COLNEY HEATH GROUP

Statement of Case – Hydrogeology

Submitted to the Appeal at the request of the Inspector reference
APP/M1900/W/24/3346607, Land at former Hatfield Aerodrome.

Map 1 - Ellenbrook Fields and the bromate plume

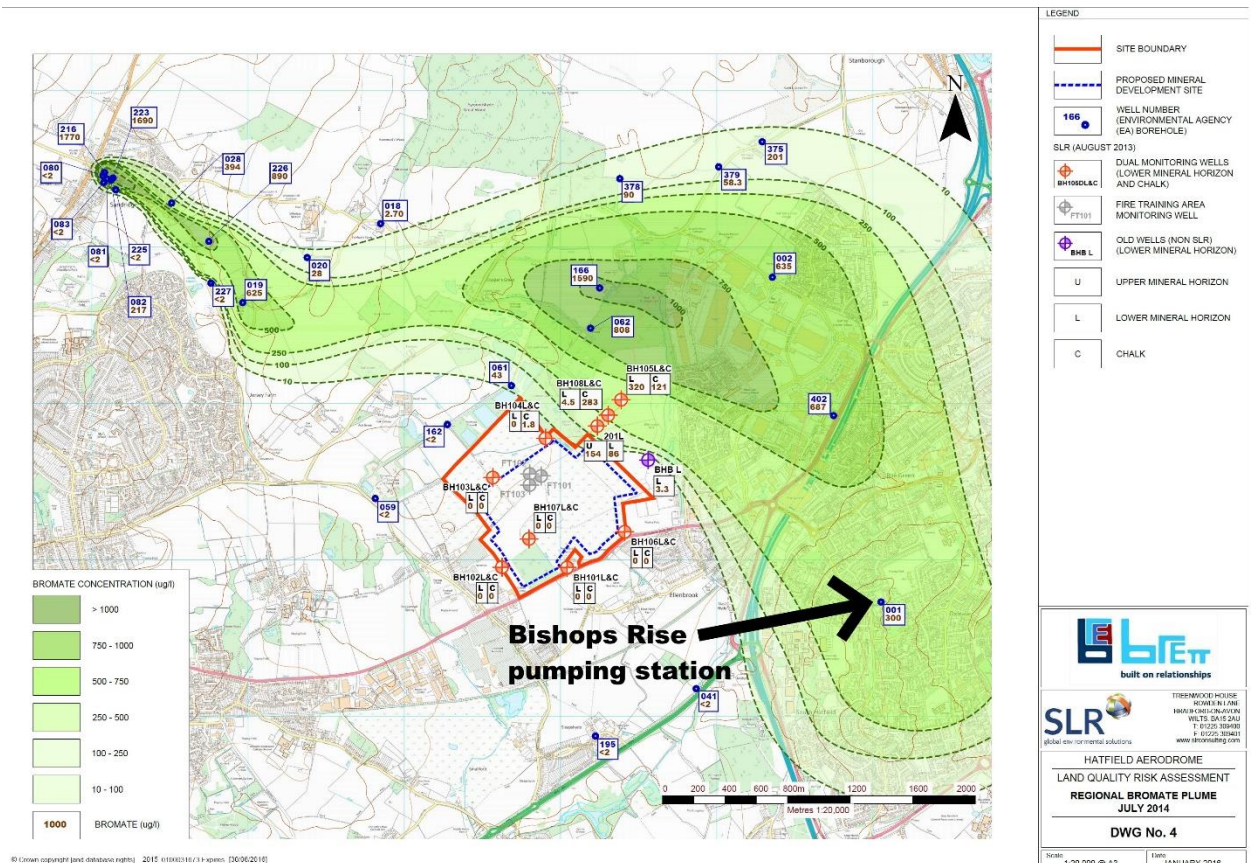
13. The proposed quarry site is less than 100m away from the theoretical / modelled edge of the bromate plume. Map 1 shows how close it is. Although a rough outline of the plume has been identified by borehole readings, clearly the bromate does not travel in straight lines and does not recognise map boundaries. Bromate migration predominantly through fissures in the chalk rock that can be quite heterogeneous and varying continuity cause the exact occurrence of contamination to be uncertain.
